DANE COUNTY DEPT. OF PUBLIC WORKS, HIGHWAY & TRANSPORTATION

ADDENDUM 1

RFB NO. 320010 - ADDENDUM NO. 1

PHOTOVOLTAIC SYSTEMS - LUSSIER FAMILY HERITAGE CENTER & LAKE FARM PARK

E201

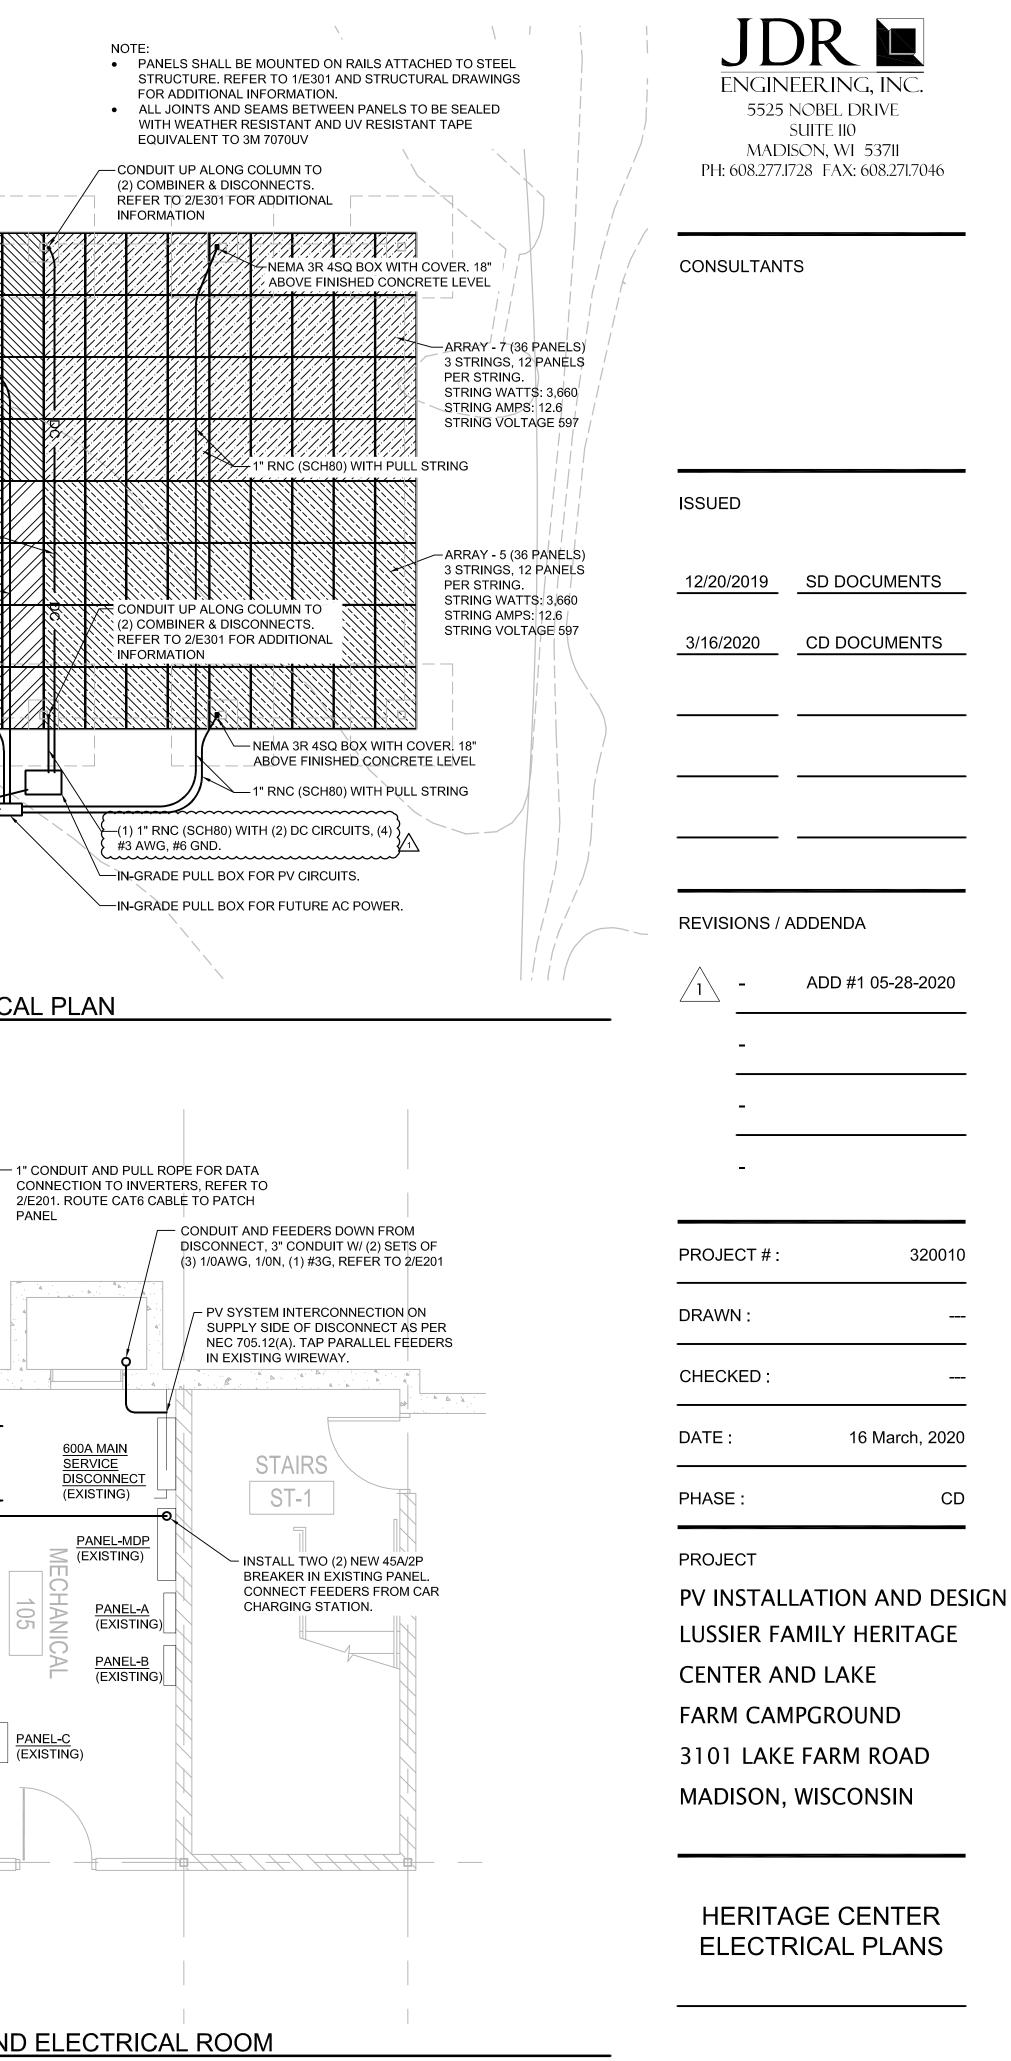
3. The conductors shown on E401 and E402 between the string combiner and the DC disconnect is listed as #8. On the array drawings, these conductors are listed as #6. Please clarify. Response: On detail 1/E201, the conductors after the dc combiner shall be #3 as indicated on 1/E401. On detail 1/E402 the conductors after the dc combiner shall be #6 as indicated on 1/E202. On detail 1/E402 the conductors indicated as #12 AWG to be (2)#10 SWG, #10 GND.

- Inverters as shown will be in the open? Will they be protected/locked/secured?
 Response: The county will be constructing a fence around the inverters at the end of the project.
- 6. Inverters on Heritage Center are drawn on the roof (E201), is it allowable to install these inverters elsewhere?

Response: Bids should be based upon the drawings. Changes to the location can be discussed as a VE item at a later time.
